STATE OF MAINE
DEPARTMENT OF TRANSPORTATION
16 STATE HOUSE STATION
AUGUSTA, MAINE 04333-0016

December 10, 2019
Subject: Little River Bridge
Replacement
State WIN: 023909.00
Location: **Gorham**
Amendment No. 1

LITTLE RIVER BRIDGE
LITTLE RIVER
GORHAM CUMBERLAND COUNTY

ESTIMATED QUANTITIES

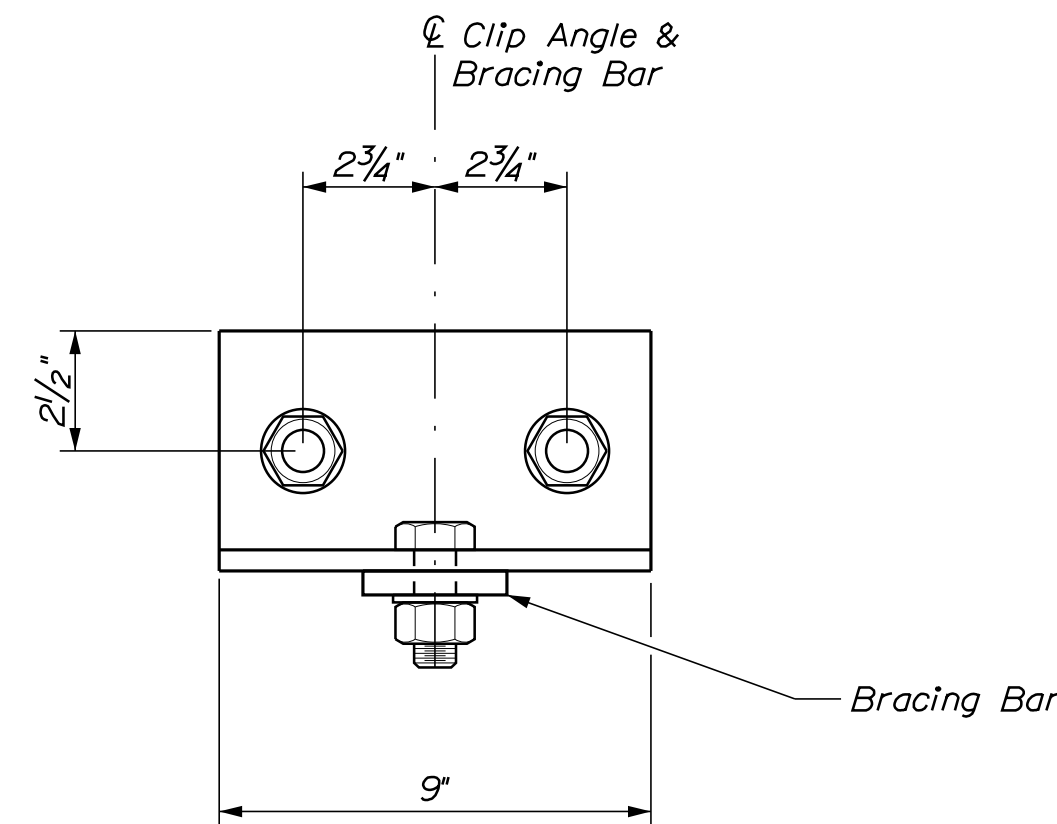
Question: Please clarify the pavement widths for Alternate 1 and Alternate 2.

Response: The Special Detours shall be paved to the width defined in the item description for each alternative on the plans.

Special Detour Widths

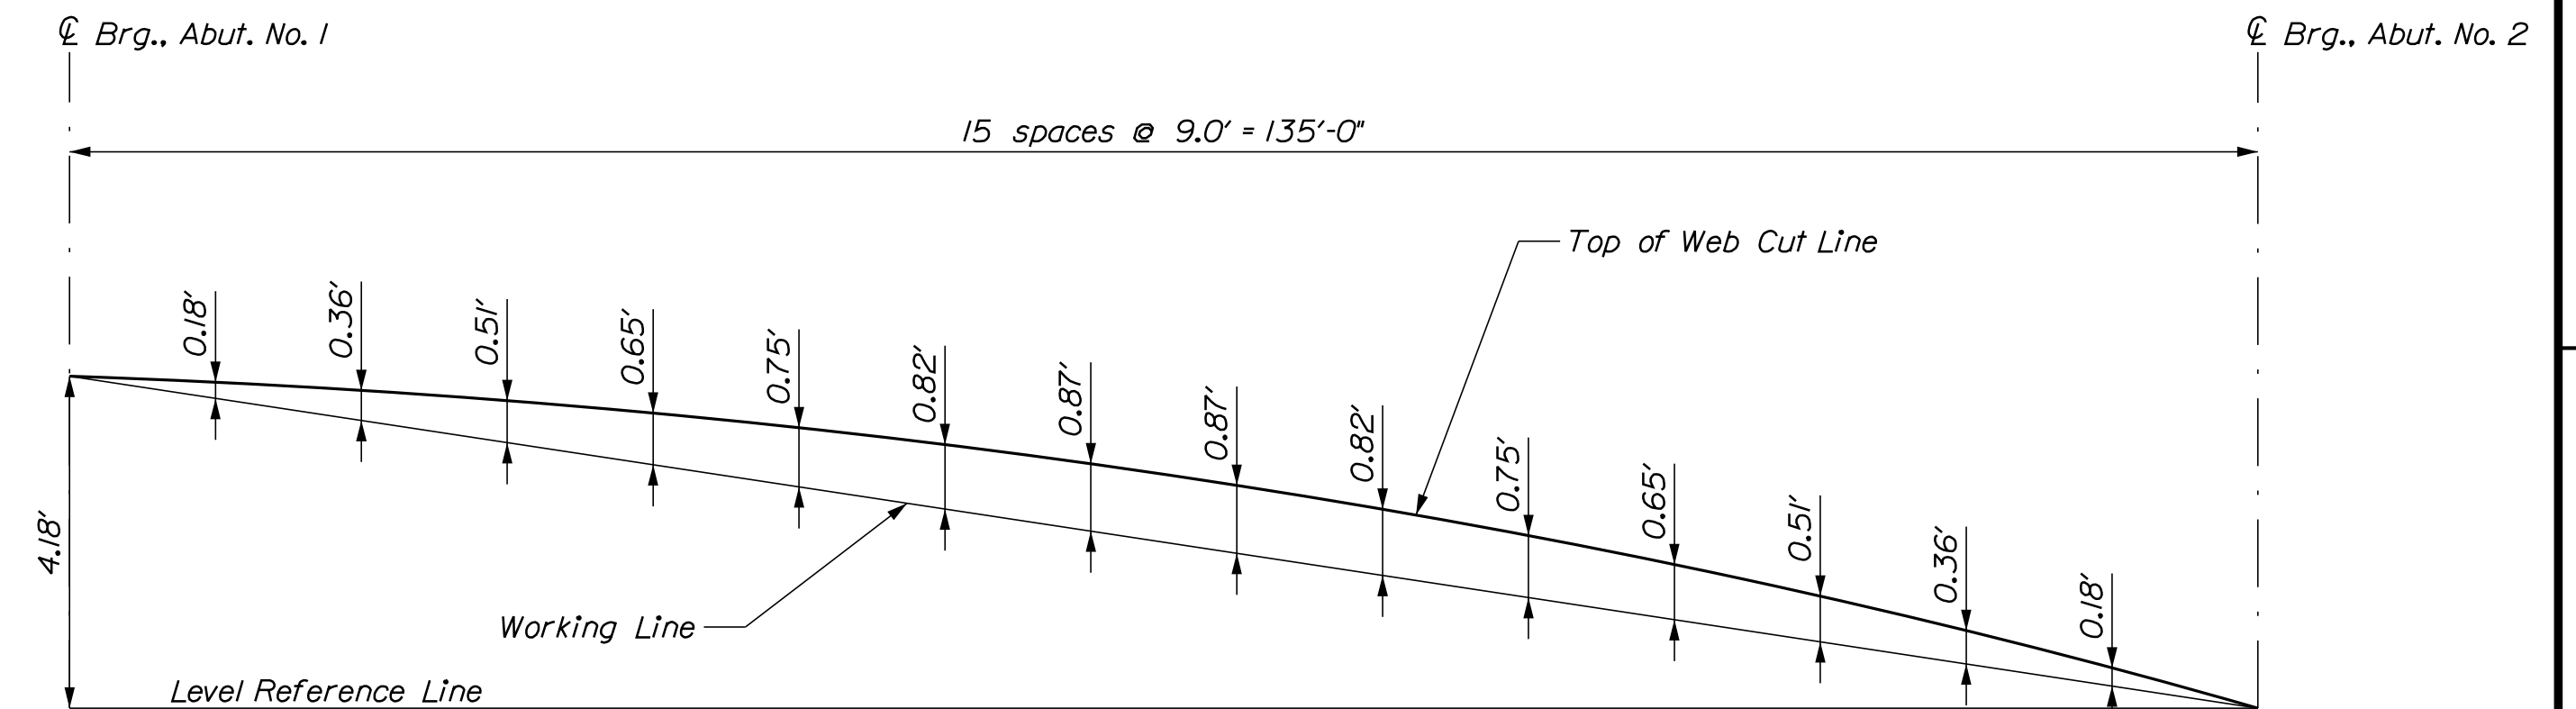
Question: Please confirm that none of the structural steel in pay item 504.702 needs to be painted (girder ends and end diaphragms).

Response: The girder ends and cross frames shall be coated to a distance 10 feet from center line of bearing, please see updated sheet 33 for more information.

8. Install all crossframes and utility supports with horizontal angle legs oriented north (up station).
9. Coat girder ends and cross frames to a distance of 10 feet from each Abutment centerline of bearing in accordance with Standard Specification Section 506, Shop Applied Protective Coating - Steel (Zinc Rich Coating System), except NEPCOAT Qualified Products List C may be used.
